Preliminary Consultation MONTGOMERY COUNTY HISTORIC PRESERVATION COMMISSION STAFF REPORT

Address: 9220 Damascus Hills Lane, Damascus Meeting Date: 5/8/2024

PROPOSAL: Partial demolition, building addition, roof alteration

Figure 11: The left-side elevation in 2021 and the proposed. The applicant proposes demolition, fenestration alteration, and an addition to the rear, outlined in red.

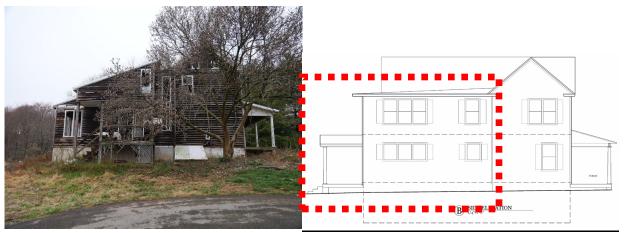
On the left-side elevation, staff does not support the triple window groupings and seeks individual windows on the addition (*Figure 11*). Staff opposes any new window openings or infills on the existing construction, and the sash windows should remain 2/2.
